Dixie-Narco®

Service Bulletin # 261

MODELS: DN Models - Red Cam
Serpentine

SUBJECT: Sold out condition which can result in product not being vended.

Fig. 1

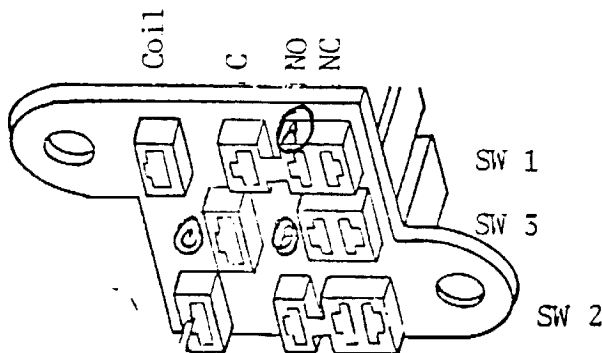
- All column sold out except one (1).
- Three cans in column.
- Set up credit - Push button and vend cycle starts.
- As can is being dispensed, sold out paddle is released and vend motor stops.

Can may be dispensed to customer
OR

Cycle may stop before can is released.

- DO THIS:
1. Remove SW 1 N.O. Terminal from (A) (Jumper) and put in SW 3 N.O. at (B).
 2. Kit would have 132" wire which has relay socket terminal on one end, insert this terminal in relay socket at (C) (common of SW 3).
 3. Run 132" wire along harness down to #1 Vend Motor SW.
 4. Find wire B44 (6 Prod) or J44 (5 Prod) which runs from N.O. of #1 Bypass SW to N.C. of #1 Vend Motor SW. Put #44 Wire in run channel of tap connector and unstripped end of 132" wire in hole in tap connector. See Instructions. Fig. 2.
 5. Insert 3 Pole Relay in Socket.
 6. For 5 column venders, approximately 117" wire is needed. Cut off to required length before putting in tap connector.
